RE: 2020 Integrated Resource Plans  
***Docket No. E-100, Sub 165***

# Clean, Affordable, and Reliable

## A Plan for Duke Energy's Future in the Carolinas

Corrected March 19, 2021

Figure 4. Sample winter peak generation by fuel type, January 2030, Mimic Duke scenario

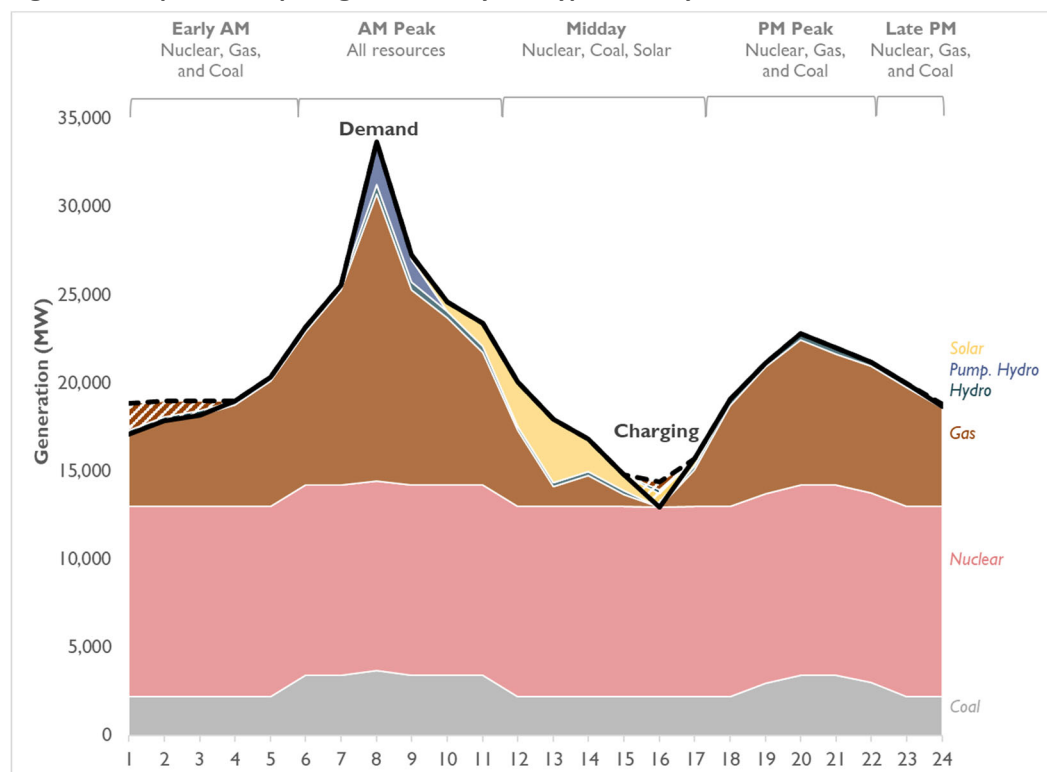
- Page 15: Renewable energy resources are now 36.2 GW in 2035.
- Page 18:
  - Figure 4: The figure has been reformatted.
  - Figure 5: The figure has been updated based on the new generation profile.
